PARCEL INFO: PID\* 10713104 SIZE: 0.66 ac PRESENT ZONING: R-3 LWPA PROPOSED ZONING: INST(CD) PROPOSED USE: DAYCARE WITH 34 CHILDREN PLAYGROUND AREA REQUIREMENTS:  $34 \times 75 \, SQ. \, FT. \, / CHILD = 2,550$ SF-- 2600 TOTAL PROVIDED PARKING REQ: 1/ 10 CHILDREN, 1/STAFF =3 FOR CHILD, 5 FOR STAFF = 8 VARIANCE GRANTED ON FRONT SETBACK ON 6/28/05 CASE \* 05-045

HEARING PETITION No. 2005-136 REVISION DATE 9-19-05

0 PLAN OSED SITE | PROP

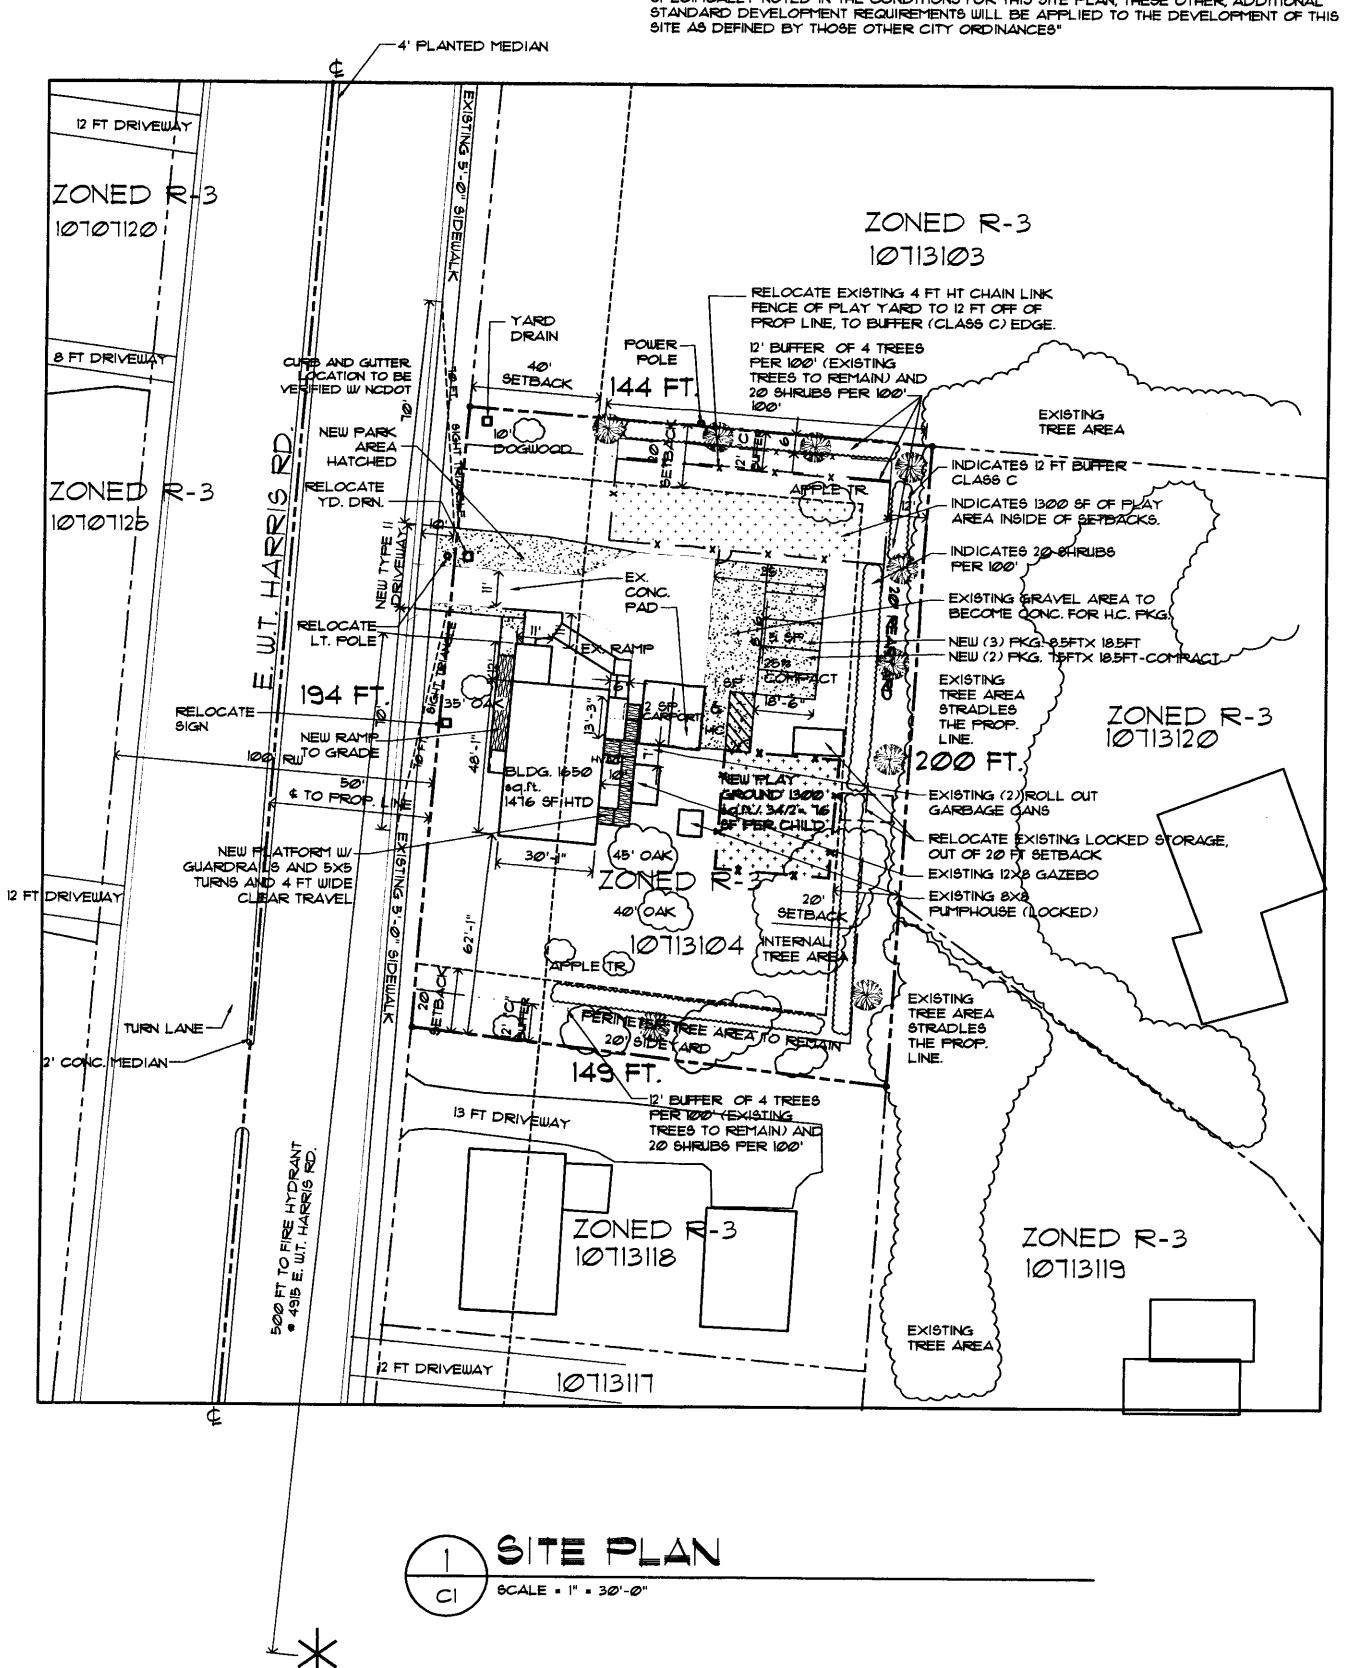
PLANNING COMMISION NOTES/ RESPONSES: DRIVEWAY TYPE, WIDTH AND LOCATION TO BE DETERMINED BY COOT.

ANY FENCE OR DRIVEWAY CONSTRUCTED ALONG OR ADJACENT TO ANY SIDEWALK OR STREET RIGHT-OF-WAY REQUIRES A CERTIFICATE ISSUED BY CDOT.

NEW/ RECONSTRUCTED DRIVEWAYS MUST BE DROP CURB RAMP TYPE II DRIVEWAYS. LOCATIONS AND WIDTHS OF ALL ADJACENT AND OPPOSING DRIVEWAYS ARE SHOWN. TYP. PARKING MODULE 19 8'-6" X 18'-6"

PARKING SUMMARY IS LISTED UNDER "DESIGN GUIDELINES" ITEM "B" "OFF STREET PARKING"
